# SYSTEM SUPPORT DIRECTIVE

ASR-9

SSM-ASR9-004

### UPGRADED MODE-S INTERFACE SUPPORT

FIGURE 1.

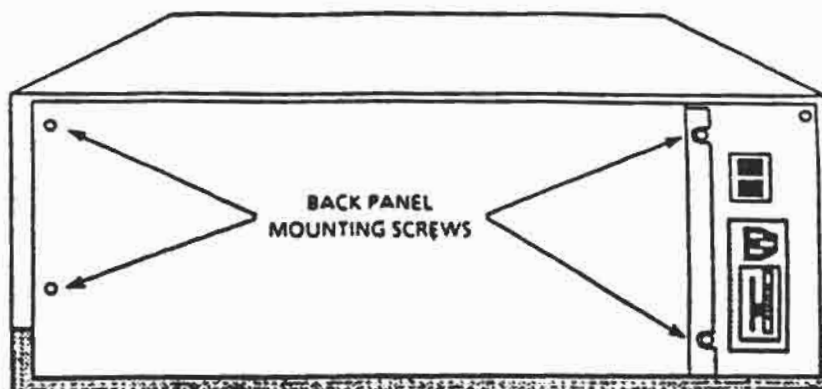
- (5) At the rear of the RMS 310 box, locate and remove the four screws which hold the cable assembly panel to the back of the unit. See appendix, figure 1.

FIGURE 2.

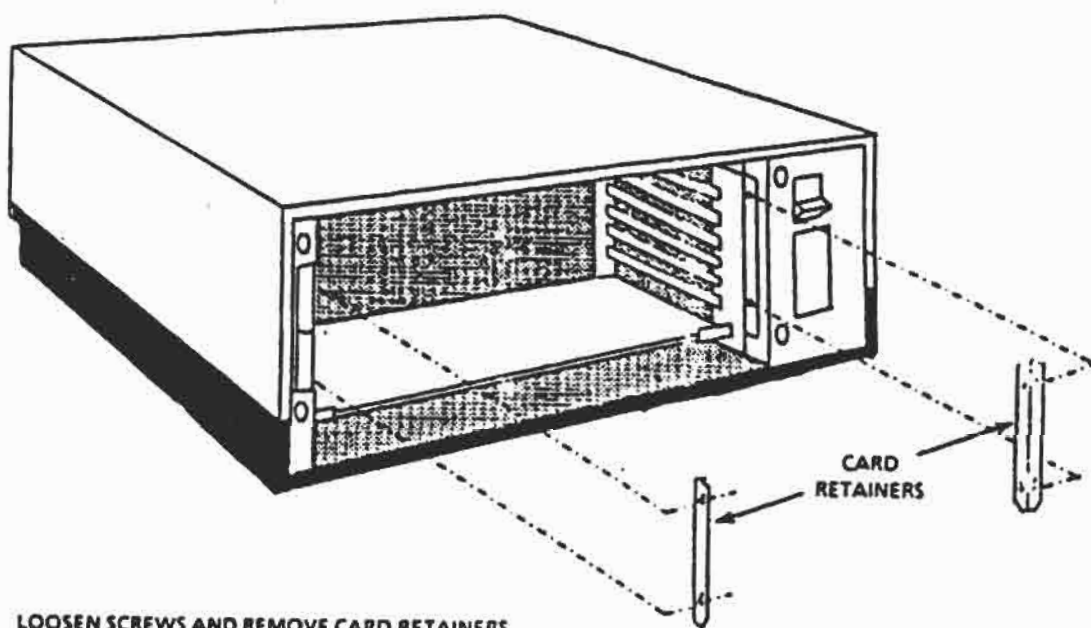
- (b) Using a marker or pen, label and detach each of the following cables: 1L, 1R, 2L, 4L, 4M, 4R, 5, and 6L.
  - (c) Remove the two metal retaining brackets that hold the circuit boards in the card cage. It is not necessary to completely remove the screws holding the bracket in place. The bracket will slide up freely once the screws have been loosened (best results seen with long handled screwdriver). See appendix, figure 2.

FIGURE 3.

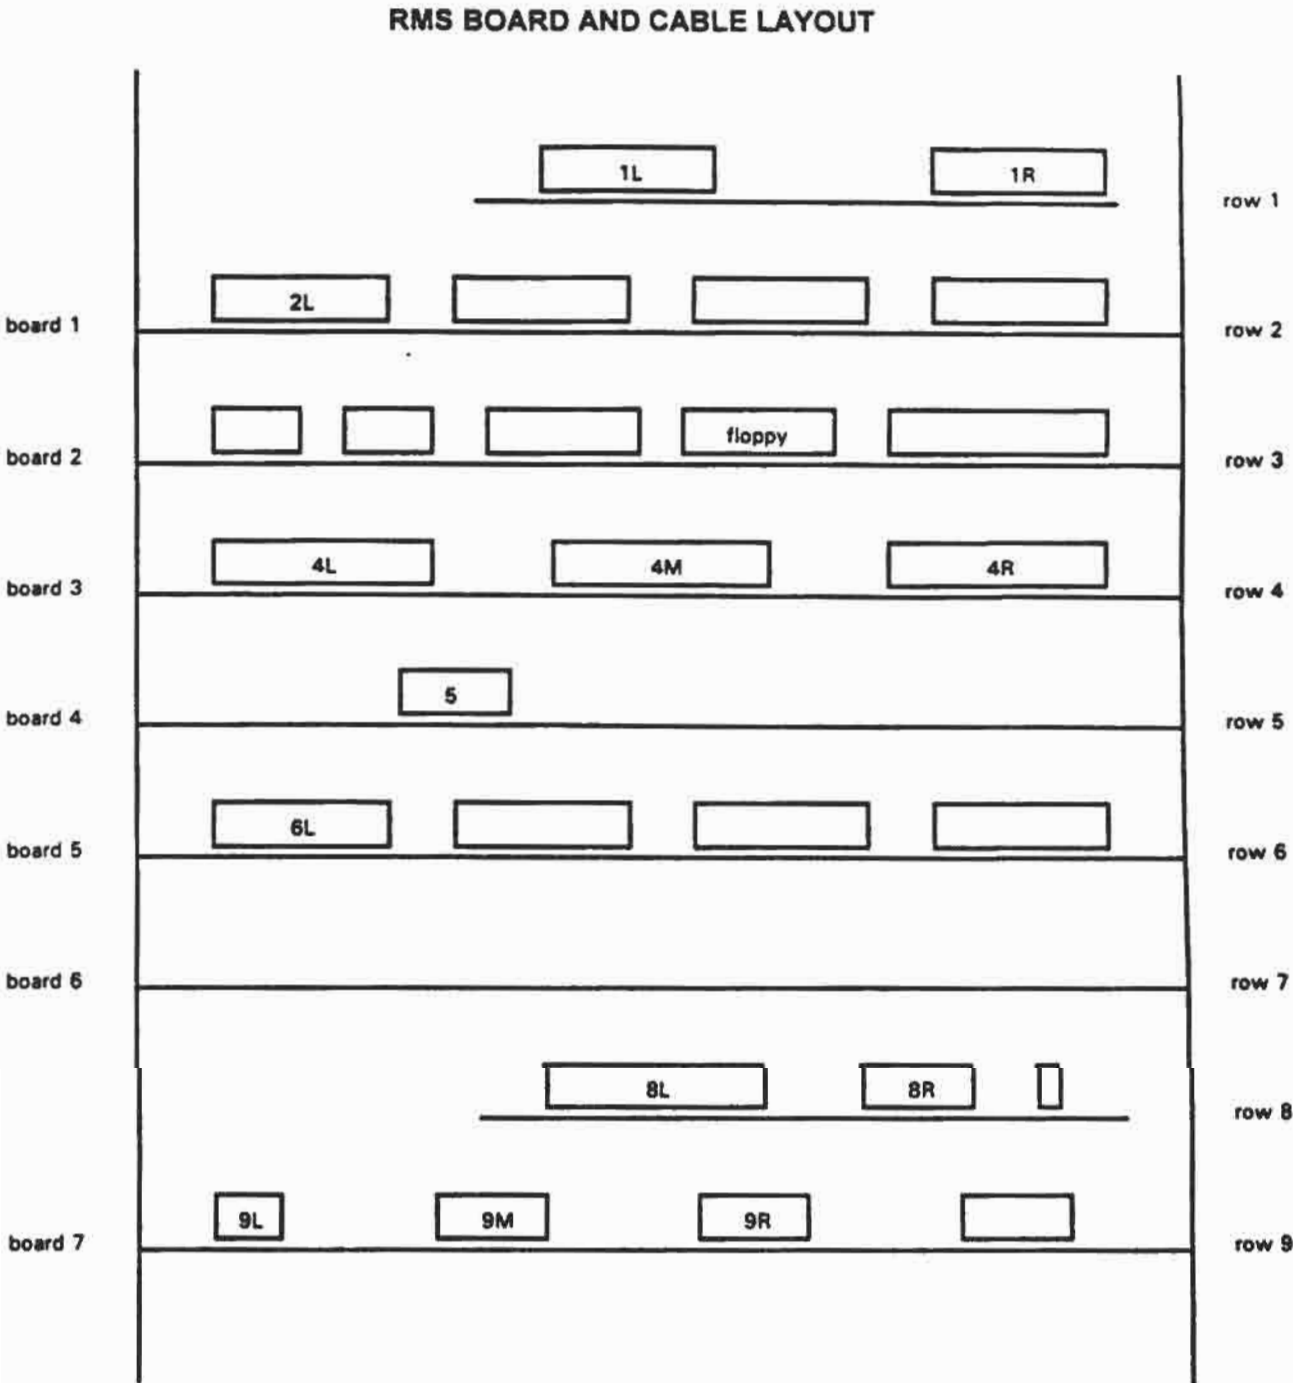
- (a) When viewed from the sides, you can see that there are seven circuit boards in the card cage. However, two of these boards (the top and bottom) have piggy-back boards on them. Thus, when viewed from the center, there appear to be nine rows of boards. When identifying the cables that attach to these boards, row 1 refers to the top board and row 9 refers to the bottom board. See appendix, figure 3.

- (8) Remove the SBC 428 EPROM expansion board from row 7. If the board proves difficult to remove, use the retaining brackets removed in step 14f(7)(c) to provide additional leverage. Figure 3 identifies this as board 6.

- (9) Remove the 12 EPROMs at U5P, U3P, U5N, U3N, U5M, U3M, U5K, U3K, U5J, U3J, U5H, and U3H. Replace them with the new chips provided in the modification kit.
- (10) Put the modified SBC 428 EPROM expansion board back into the RMS 310 box. When seated properly, this board will be even with respect to the neighboring boards (must not be sticking out).
- (11) Reinstall the two metal retaining brackets.
- (12) Reattach all the short internal cables that were detached in step 14f(7)(b).
- (13) Reattach the cable assembly panel to the RMS 310 box using the four screws removed in step 14f(5). If two are sheet metal screws and two are machine screws, then the sheet metal screws should go on the left side, as viewed from the rear of the box.
